**Accredited SDA Assessor – Update 4 - December 2021**  
**Clarifications re the SDA Design Standard Interpretations**  
**December 2021**

This is the 4th update of Clarifications re the SDA Design Standard Interpretations. This 4th Update also includes the content from Updates 1, 2 and 3. Apart from some grammatical modifications, **changes in this document made since Update 3 are highlighted in purple.**

[Figure 1- Image of Checklist showing new question applicable to refurbished dwelling]

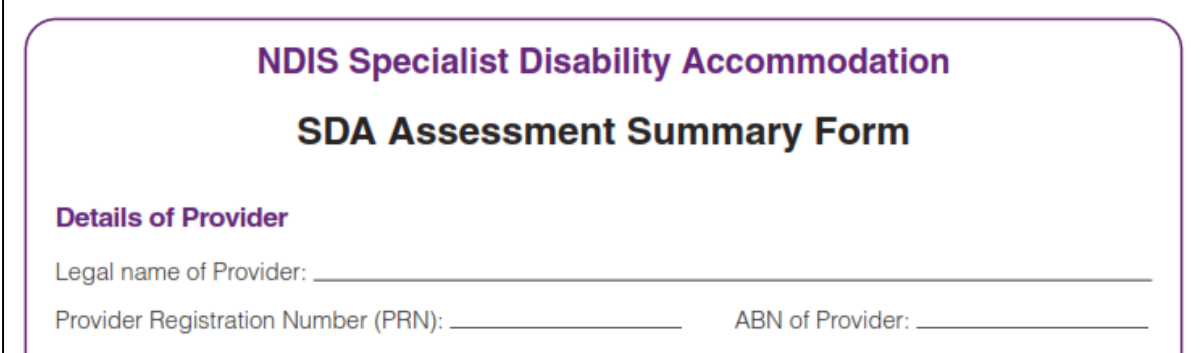
The checklists for all four Design categories have been updated to include a line that requires the assessor to tick a box to state if the Checklist applies to a refurbished dwelling.

Assessors are only required to identify this on the Checklist and are not required to check if the minimum refurbishment costs are met as that will be checked by the NDIA.

SDA Assessors are required to start using the new Checklists as soon as practical or latest by 1st March 2022. Copies of the new checklists will be distributed by LHA.

Figure 3- Flowchart showing requirements where same (full) dwelling is certified for various design categories]

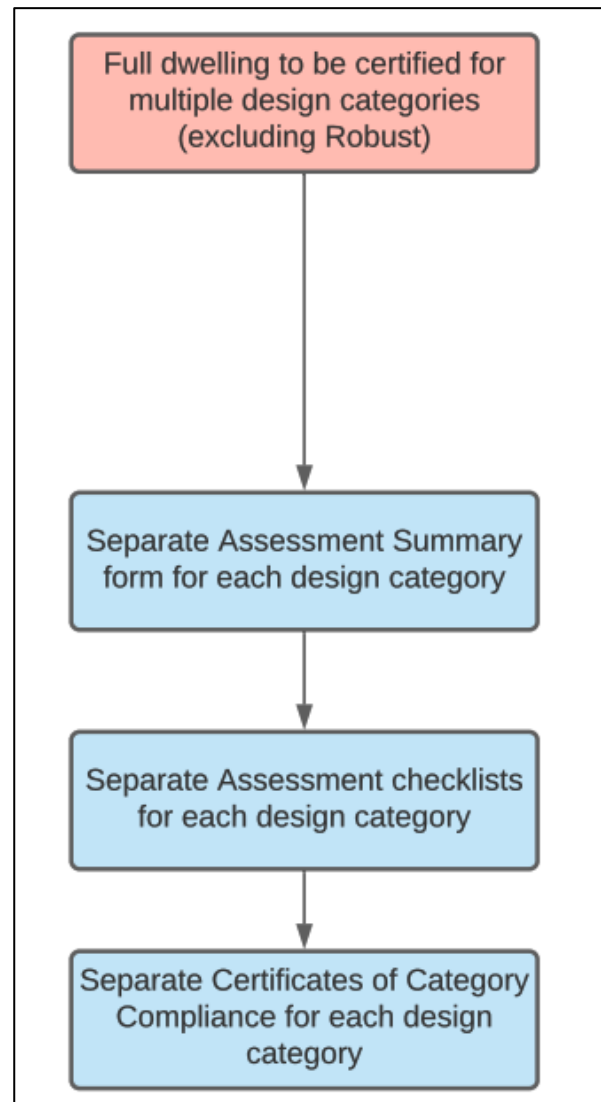
A dwelling can be certified under multiple design categories when assessment is via the SDA Design Standard.

For example, a 4-bedroom group home can be designed to meet the requirements of HPS and IL in which case all bedrooms are certified as HPS but can also be used for IL if required.

In this case separate Assessment Summary forms, separate Assessment checklists and separate Certificates of Category Compliance are required for each of the design categories to be certified.

An individual dwelling can be certified for the three design categories of IL, FA and HPS but not Ro. This is because there are elements required in IL, FA and HPS that may not be suitable for Ro. For example, use of AS1428.1 compliant door handles as required in Clause 4.2.6 or shower hose as required in Clause 7.1.7 may not be suitable for use in Ro dwellings.

[Figure 4- Flowchart showing requirements where parts of a dwelling are certified for various design categories]

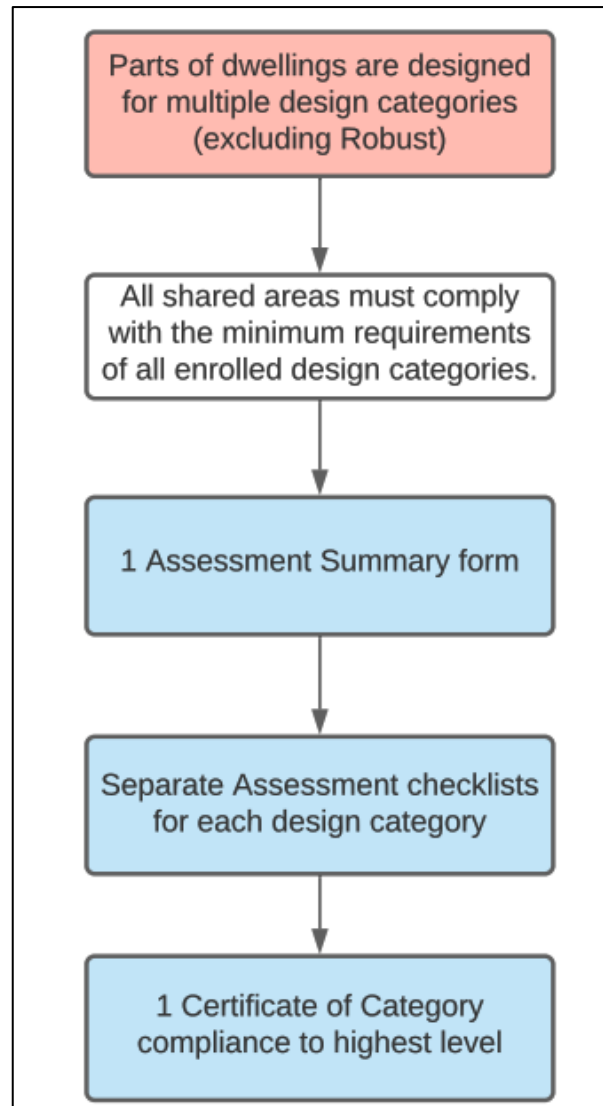
A dwelling can be certified under multiple design categories when assessment is via the SDA Design Standard. For example, a 3-bedroom apartment is designed such that 1 bedroom is designed as per HPS and 2 bedrooms are designed as per IL.

In this case all shared areas must comply with the minimum requirements of all enrolled design categories.

In this case only 1 Assessment summary form, 1 Certificate of compliance (to the highest level) and separate Assessment checklists are required for each of the design categories to be certified. The Assessment summary form has a table which can be filled in to reflect the allocation of the bedrooms to the various design categories.

[Figure 7- Figures clarifying the requirements of accessible benchtop locations in kitchens]

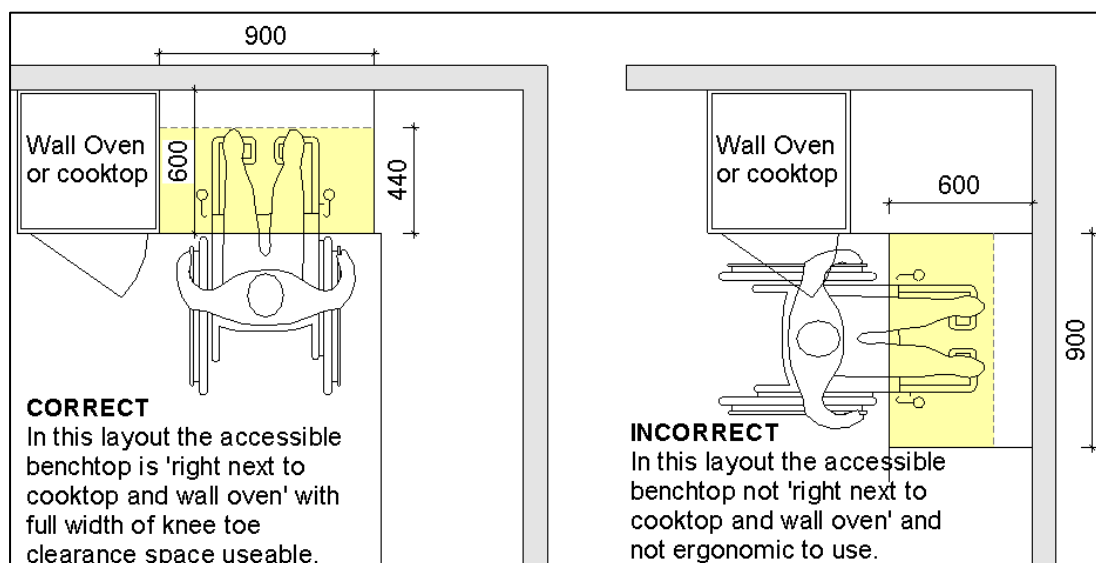
Clause 8.6, for FA and HPS design categories, the accessible benchtop surface of a minimum 600mm depth shall be provided 'right next to' the cooktop and wall oven on the latch side of the oven door.

'Right next to' means abutting the cooktop and wall oven (i.e., same wall as that of the wall oven and cooktop) as indicated in figure below.

The diagrams above show location of the 'accessible benchtop' in relation to the oven or cooktop.

Rationale: Accessible benchtop at 90-degree bends or at corners makes it difficult for a person who uses a wheelchair to move items from within the oven or from the cooktop, then turn wheelchair 90 degrees to place the items on to the accessible benchtop. This location may also cause issues with operation of a side hinged oven door.

[Figure 9- Figure showing a sample design of bedroom with ensuite and private open space / balcony access]

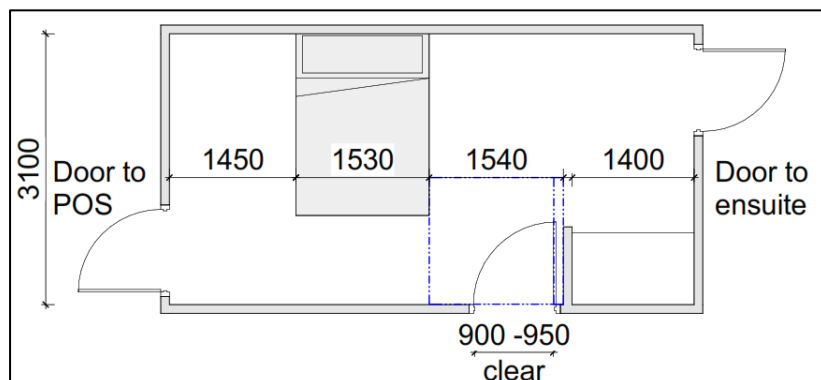
For FA and HPS, where there is an ensuite access for the participant from within the participant's bedroom, or access to a balcony or POS (Private open space) from within the participant's bedroom, the door circulation spaces of the ensuite door / door to balcony / POS are required to be clear of the space required for the bed.
